# Product Change Notification

## 110933 - 00

<b>Change Notification #:</b>	<b>110933 - 00</b>
<b>Change Title:</b>	<b>Intel PRO/1000 PT Quad Port LP Server Adapters, EXPI9404PTLBLK MM#884311, EXPI9404PTL MM#884309 (Kirkwood LP Retail)</b>  <b>PCN 110933-00</b>  <b>Label Software</b>  <b>Updating KCC (Korean Communications Commission) logo to the new KC logo on PB (printed board) and all box labels, OUI Block change and Software CD change</b>
<b>Date of Publication:</b>	<b>Aug 12, 2011</b>

New KC logo, Date of Manufacture, Product Identification number, Made in COO (Picture 4, all of the information showing in Picture 4 is for example only and may not reflect actual data)

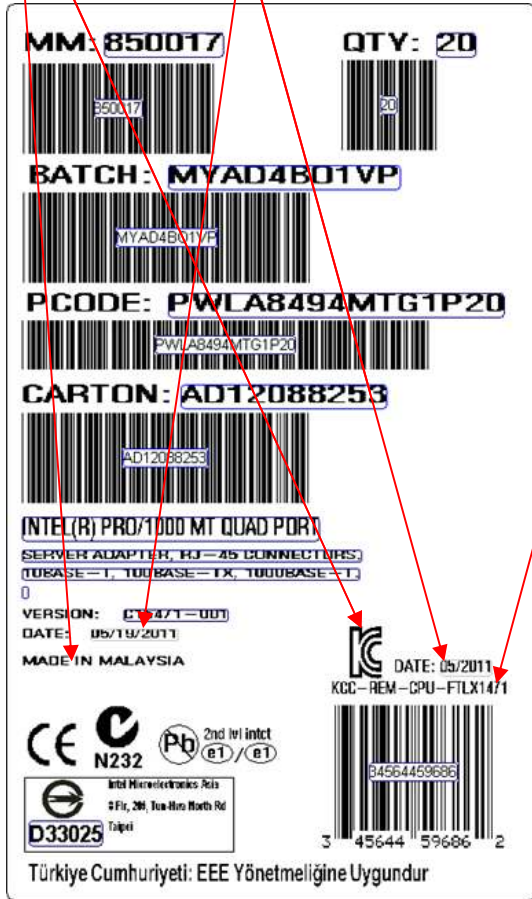
To comply with new regulations from Korea, Intel will be adding the new KC logo to the Printed Board (PB) as a label. The label will be added to either the front or the back of the PB depending on space constraints. The new KC logo will also be added to all box labels (product box label and over-pak box label). **(see pictures 1, 3 & 4)**

Picture 4 showing new KC logo on box label. The box label already contains the Made in Country of Origin (COO) and the Date of Manufacture, this information will also show on the KC label.
